UN#09-100

Subject: Joint Federal/State Application of Calvert Cliffs 3 Nuclear Project, LLC and UniStar Nuclear Operating Services, LLC, Calvert Cliffs Nuclear Power Plant Site, Lusby, Calvert County, Maryland, USACE Tracking No. NAB-2007-08123-M05

Application NAB-2007-08123-M05
Response to U.S. Army Corps of Engineers Information Request Dated 10/28/08
Calvert Cliffs 3 Project, LLC and UniStar Nuclear Operating Services, LLC
Revision 1 - January 20, 2009

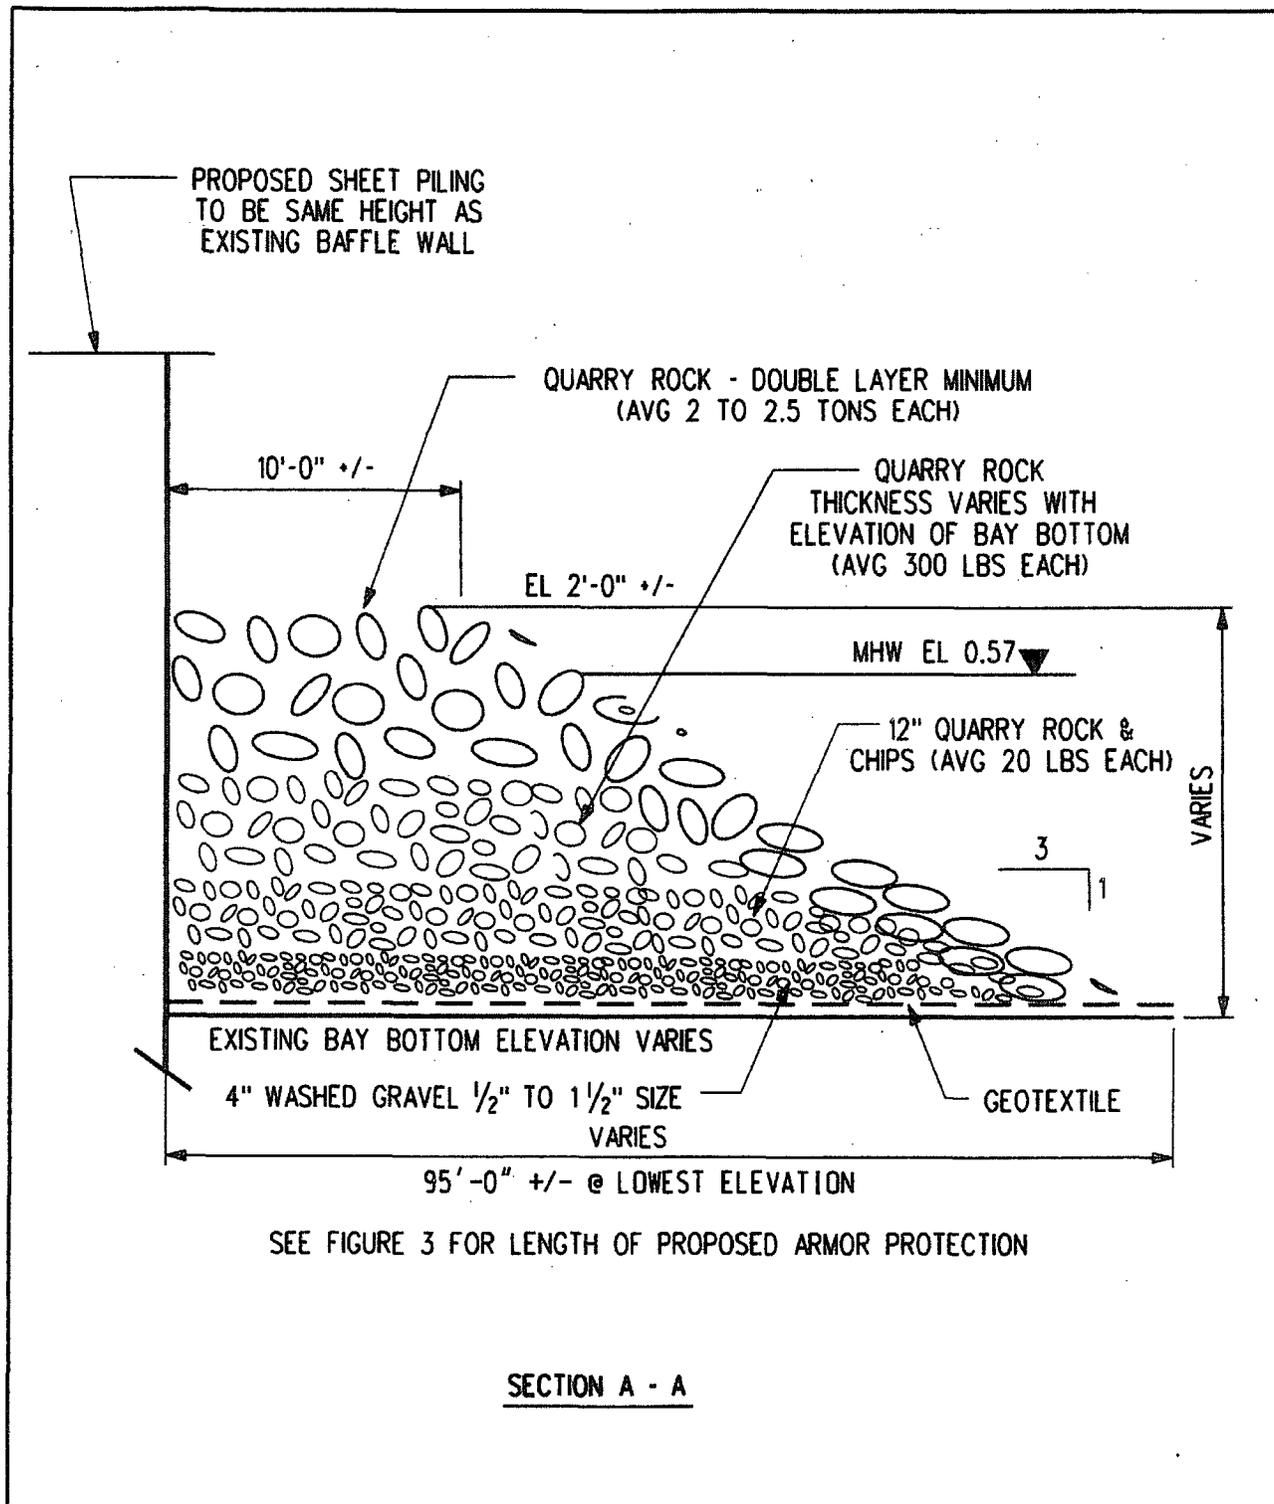
- a. Reduce the width of the proposed dredge channel to the minimum necessary for barge ingress and egress and to ensure dredge barge access for the proposed method of dredging**
- b. Reduce the stone revetment footprint channelward of the intake area.**
- c. Reduce the length and width of the impact area for the discharge pipe and fish return to the minimum necessary to meet the purpose of these projects aspects.**

- 5b. The width at base of the riprap protection of 115-ft can be reduced based on the contour and 3:1 slope, to 95-ft. with toe included. This goes to a bottom elevation of El. -22 ft. (shown on Figure 3A). Separately, the top width of armor protection will be changed to 10-ft. instead of 6-ft., as shown.**

- 5a. The barge area width duplicates the original design for Units 1 and 2 (i.e., maintenance dredging) and is based on allowing for up to 4 barges to be moored at given time to accommodate deliveries during the peak construction period. For reference, see original plant drawing C-29, titled "Offshore Construction Plan - Sheet 2.**

A revised Figure 3-B is attached.
